Rear Air Disc Brake Axle Shaft Flange Nut Replacement

BULLETIN

Models Affected: 2015 through 2017 Vision and All American with Air Disc Brakes

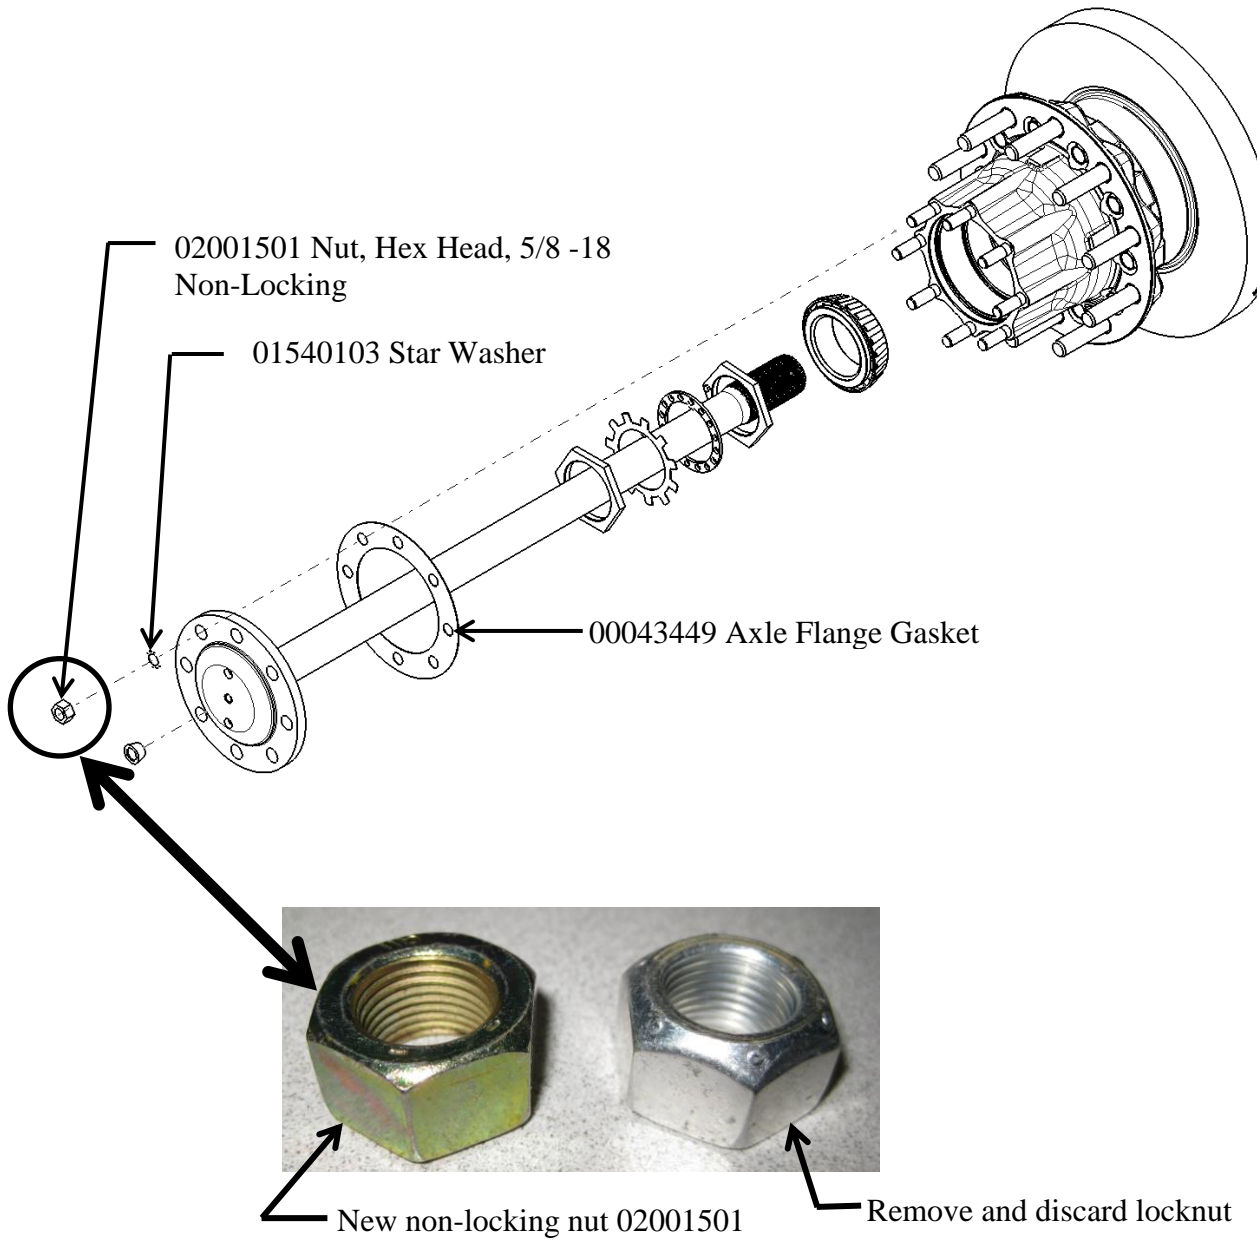
Rear axle shaft flange nut torque reduces allowing for oil leak between the axle shaft and hub.

Replace the existing rear axle flange lock nut with a new non-locking nut and star washer. Request that the Service Manual be updated by technician to show new nut and torque.

1. Park bus on level surface, turn off engine, remove ignition key, and chock wheels.
2. To reduce the possibility of the stud being removed when removing locknut, remove the paint from the existing rear axle shaft flange studs.
3. Remove and discard the first lock nut and star washer.
4. Replace the hardware in Step 3 with a new star washer 01540103 and a new non locking nut 02001501.
5. Torque nut to 60-70 ft-lb.
6. If a stud comes out during removal of locknut, remove the locknut from the stud and reinstall the stud into the hub. Torque stud to 60 to 70 ft-lb.
7. Remove the next lock nut and star washer in a “star” pattern.
8. Repeat Steps 3 to 6 until all eight star washers and lock nuts are replaced.
9. Re-torque all nuts to 170-180 ft-lb. in a “star” pattern.

NOTE 1: If there is a leak at the rear axle flange gasket, remove and discard all eight locknuts and star washers. Replace gasket, install axle shaft, and install eight new star washers 01540103 and new non-locking nuts 02001501. Torque all eight nuts per Step 9 above.
